**FINAL DRAINAGE REPORT
FOR
RETREAT AT TIMBERRIDGE
FILING NO. 1**

Engineering Review
11/12/2019 2:42:46 PM
dsdrice
JeffRice@elpasoco.com
(719) 520-7877
**EPC Planning & Community
Development Department**

PCD Project No. SF-19-009

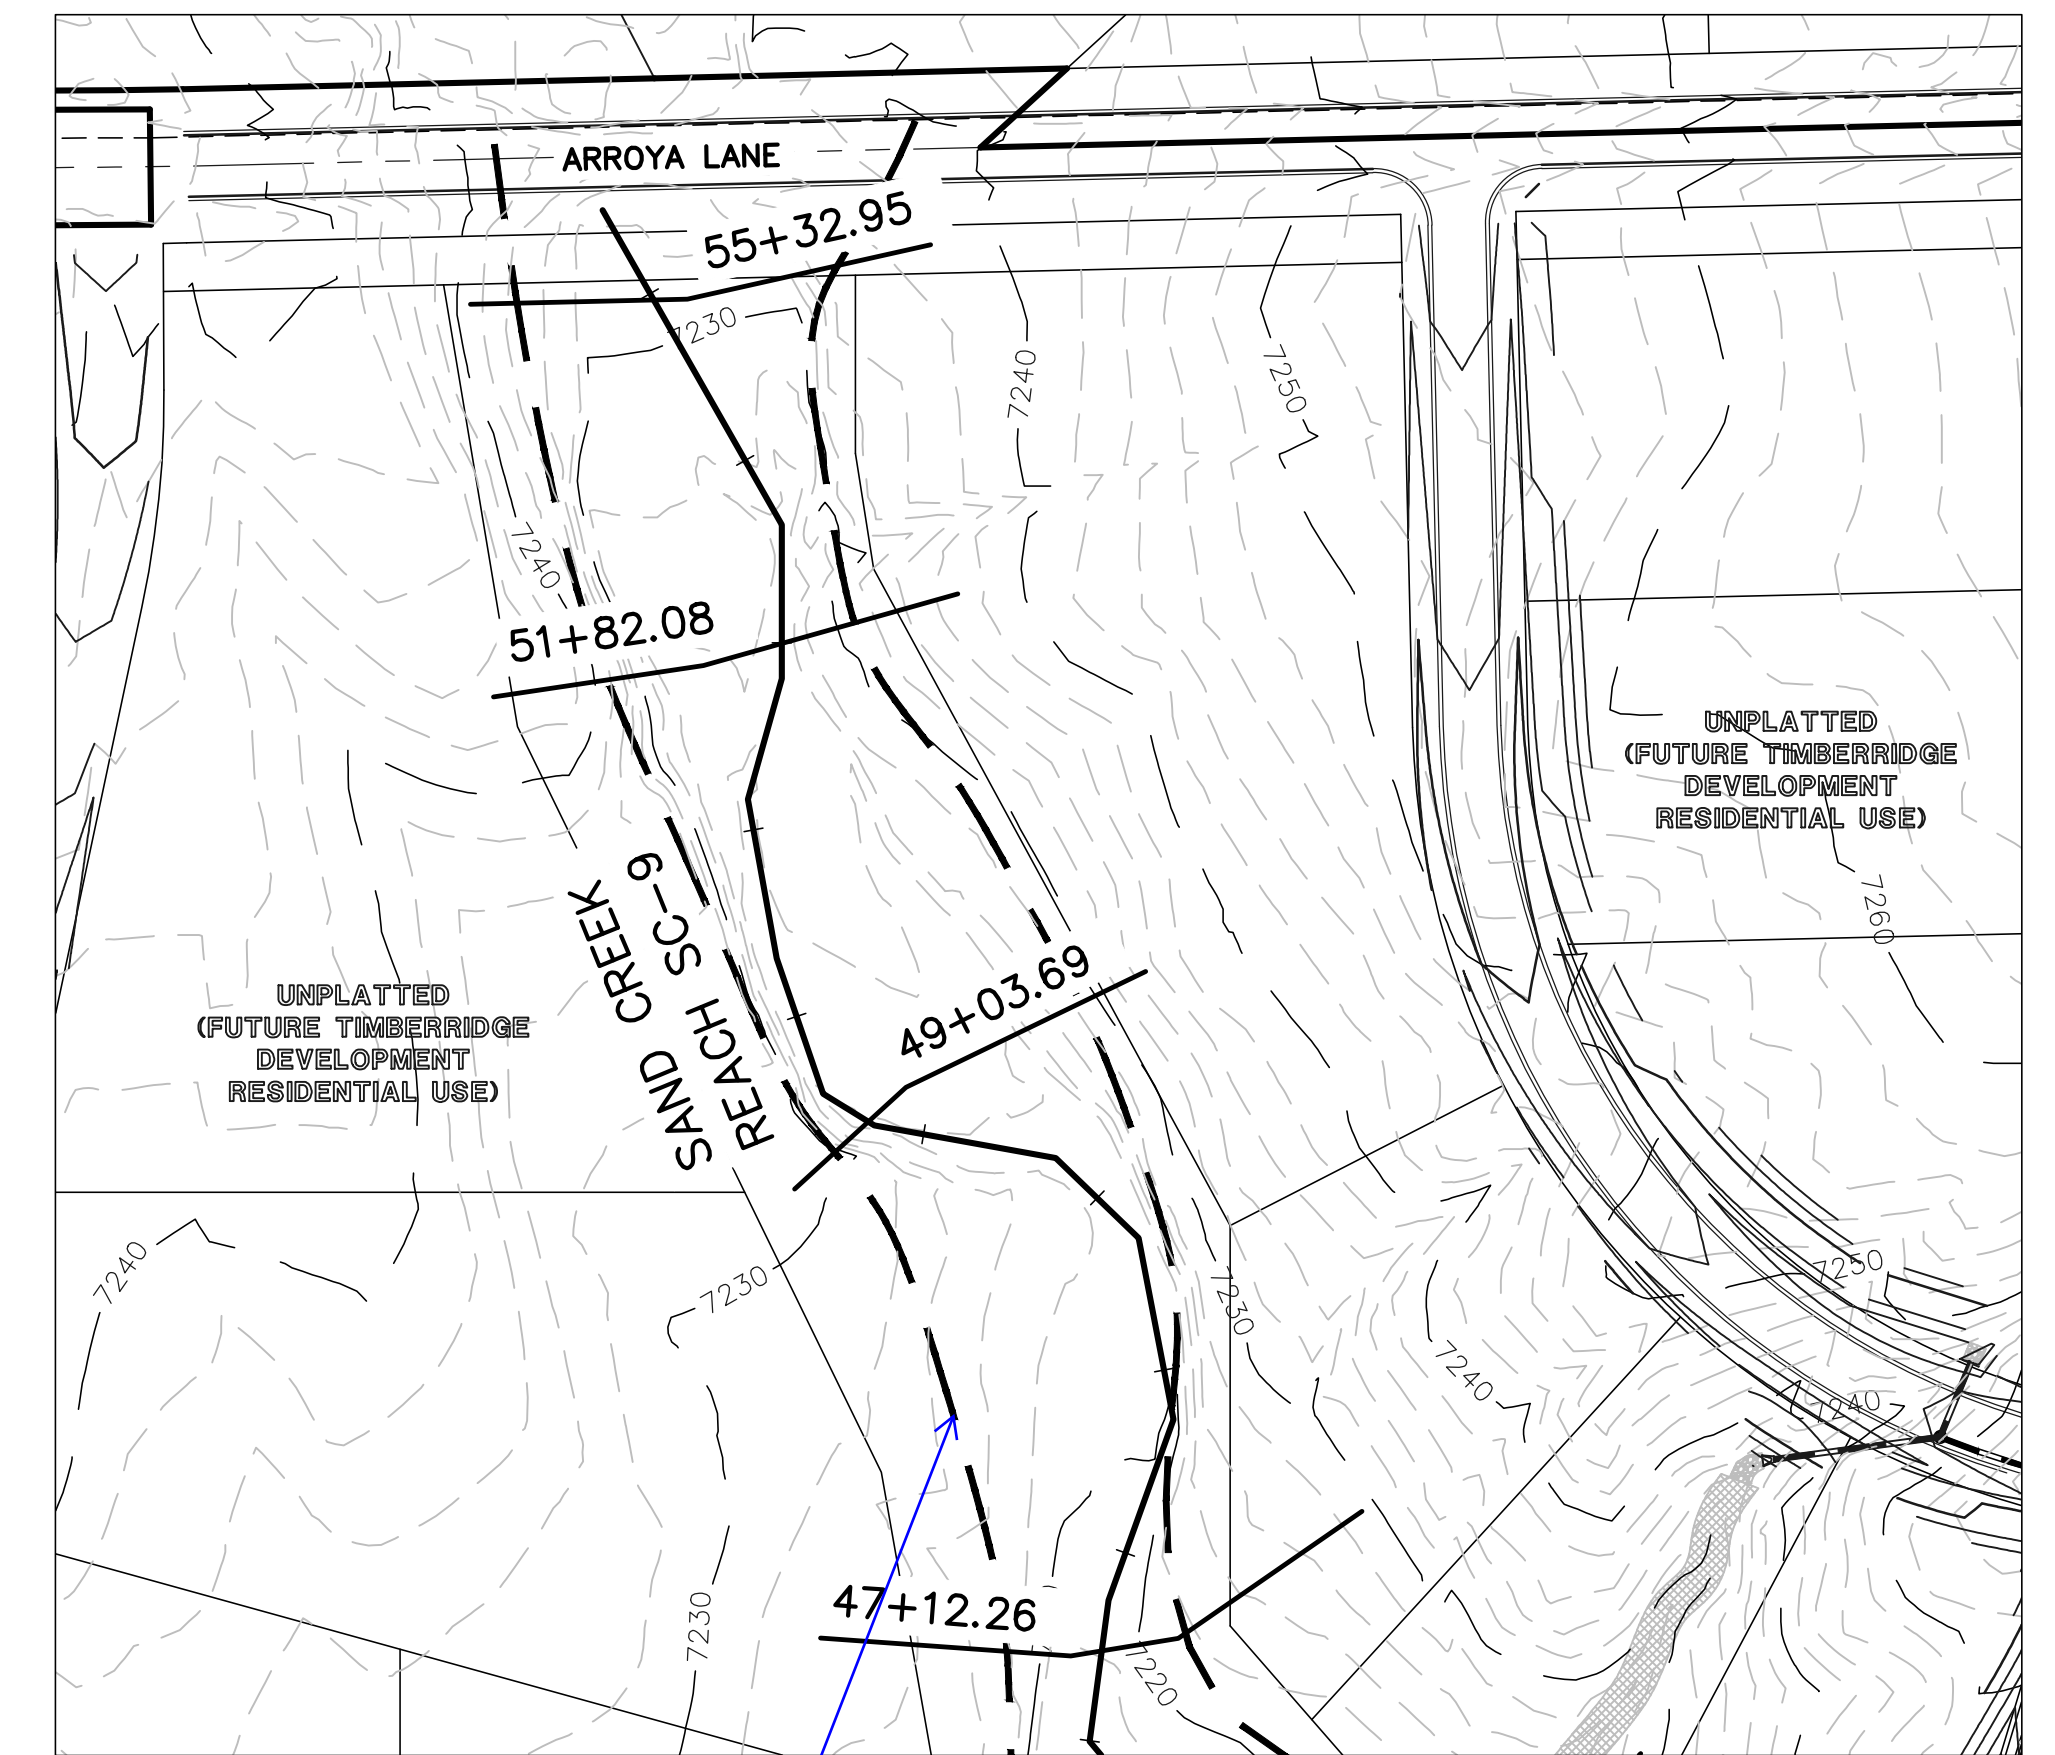
Label which floodplain line these are (FEMA 100-year flow?).

THE RETREAT AT TIMBERIDGE FILING 1 FINAL DRAINAGE REPORT DEVELOPED DRAINAGE MAP (INCL. FUTURE TIMBERIDGE DEVELOPED BASINS)	
		DESIGNED BY	MAW
619 N. Cascade Avenue, Suite 200 Colorado Springs, Colorado 80903		(719)785-0790 (719)785-0799 (Fax)	1-31-19 SHEET 2 OF 5 JOB NO. 2520.00

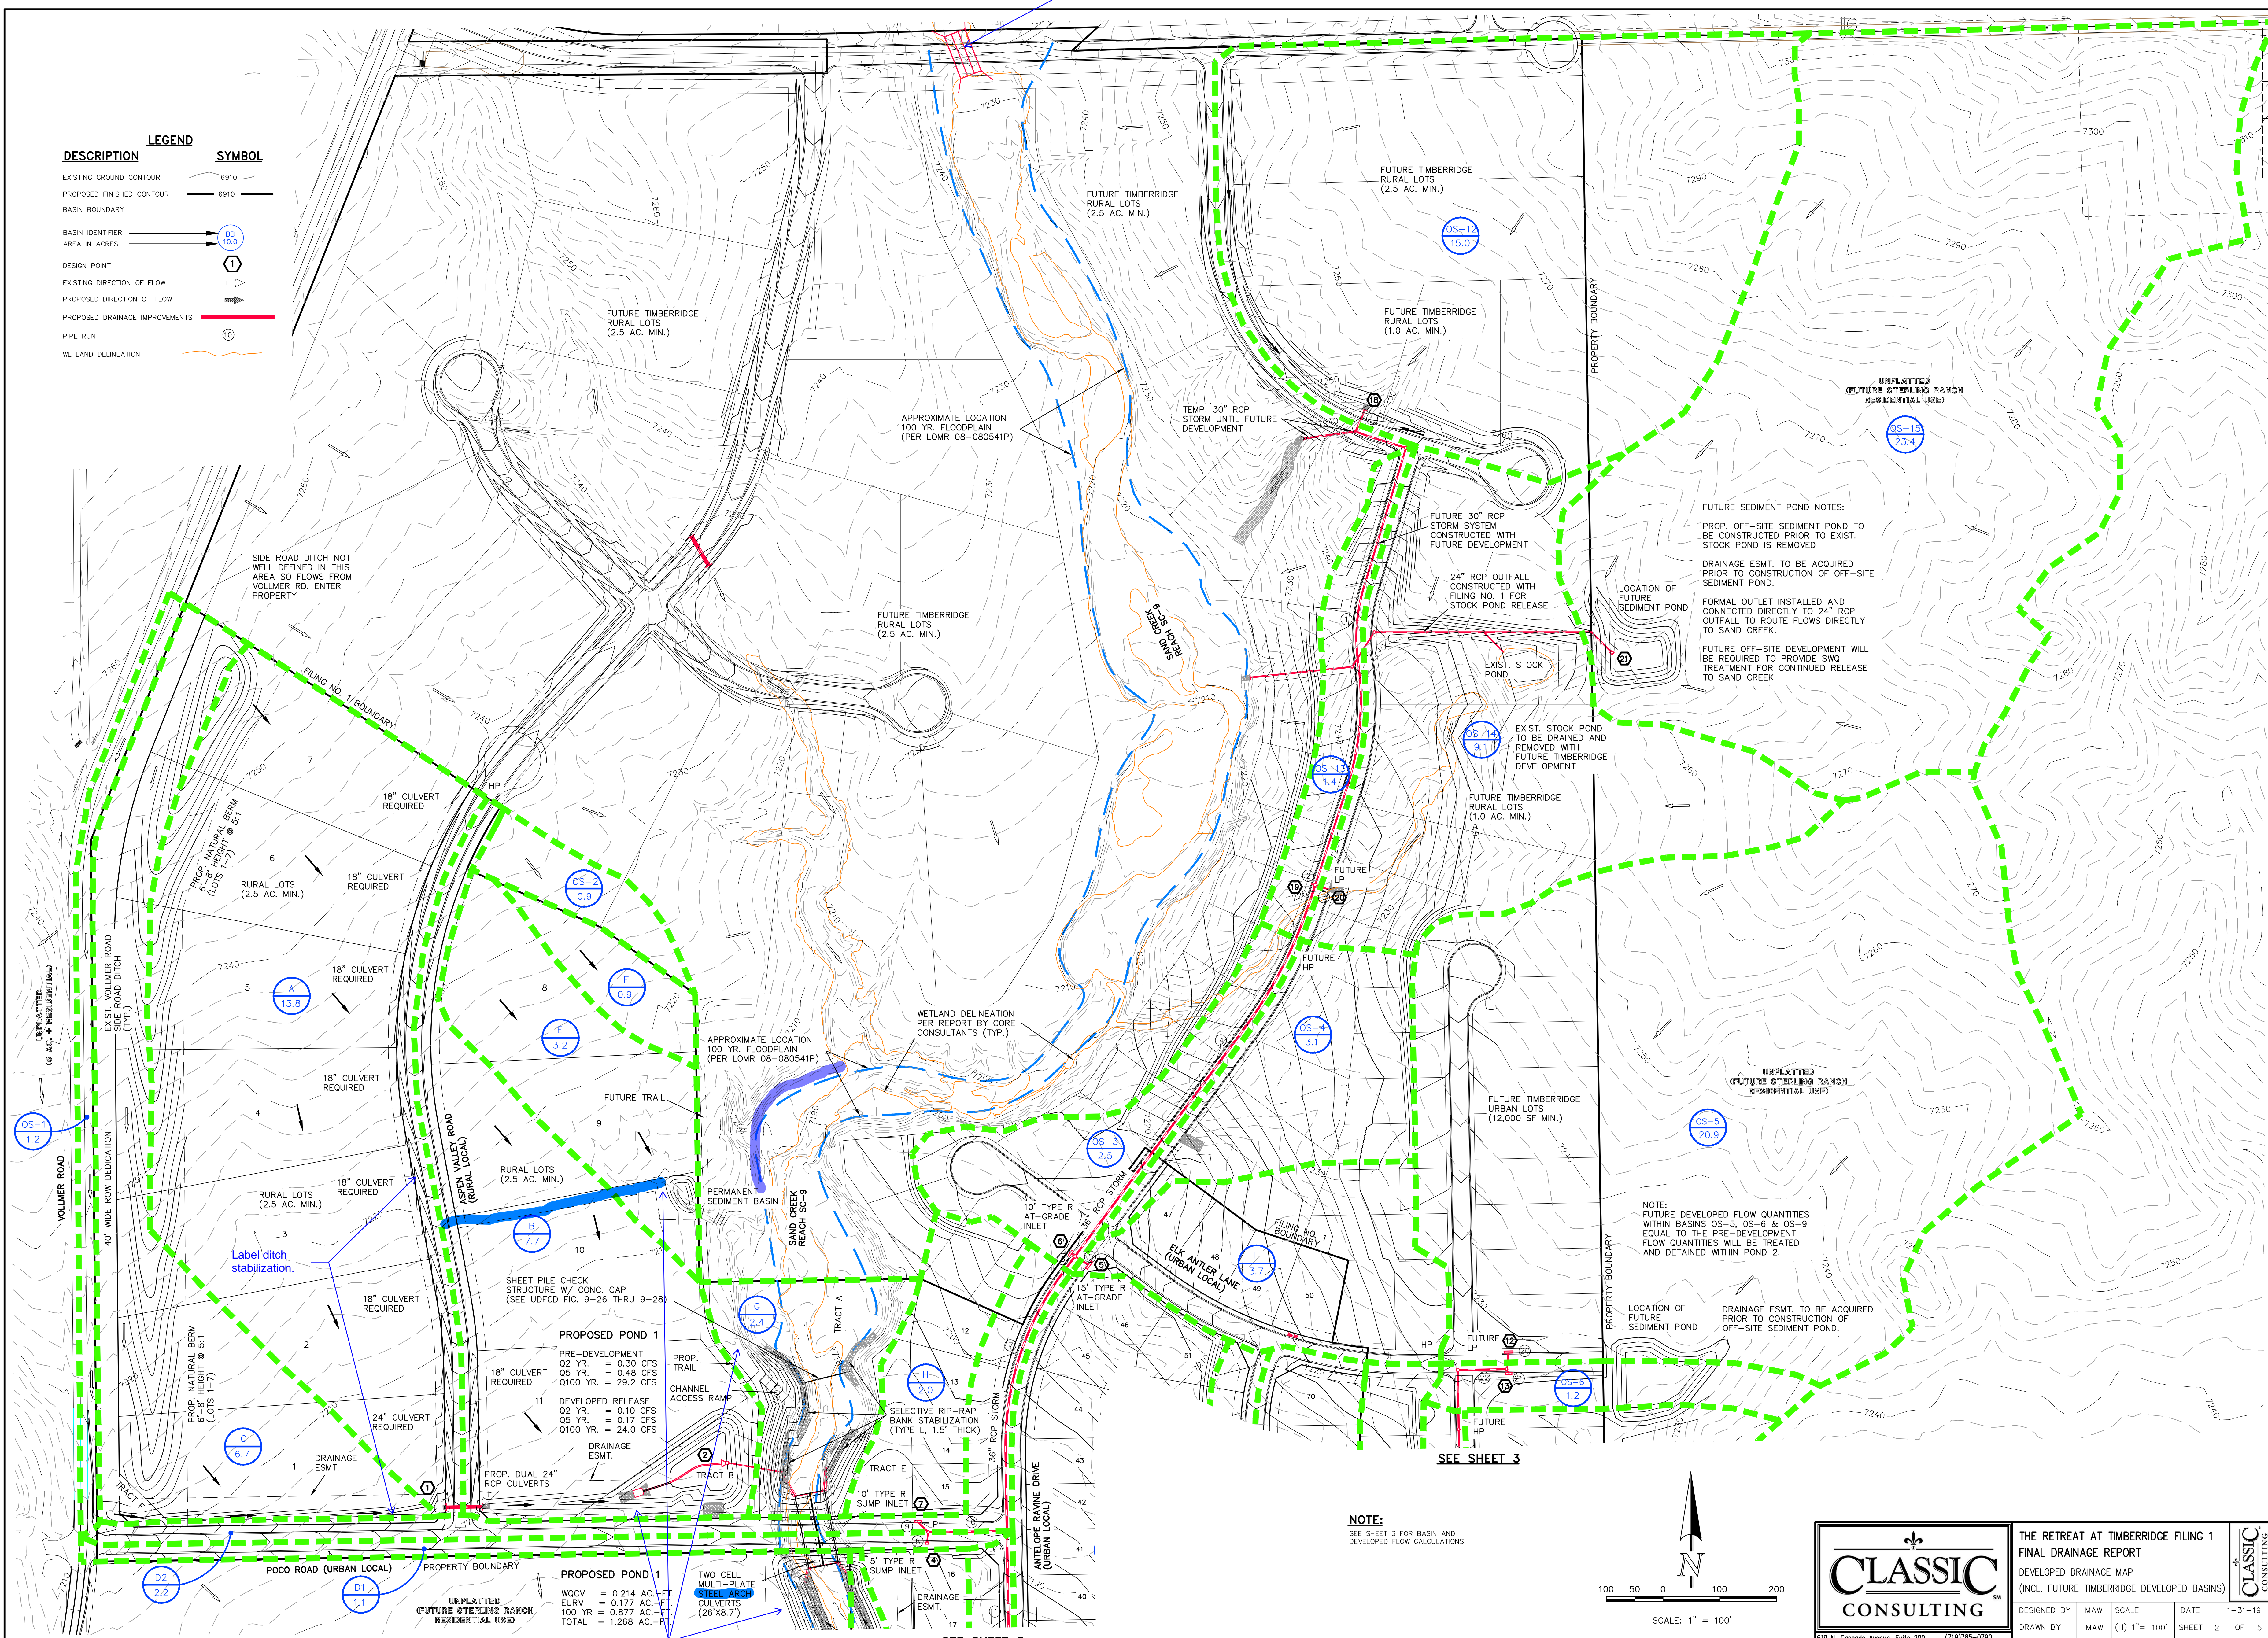
Label ditch stabilization.
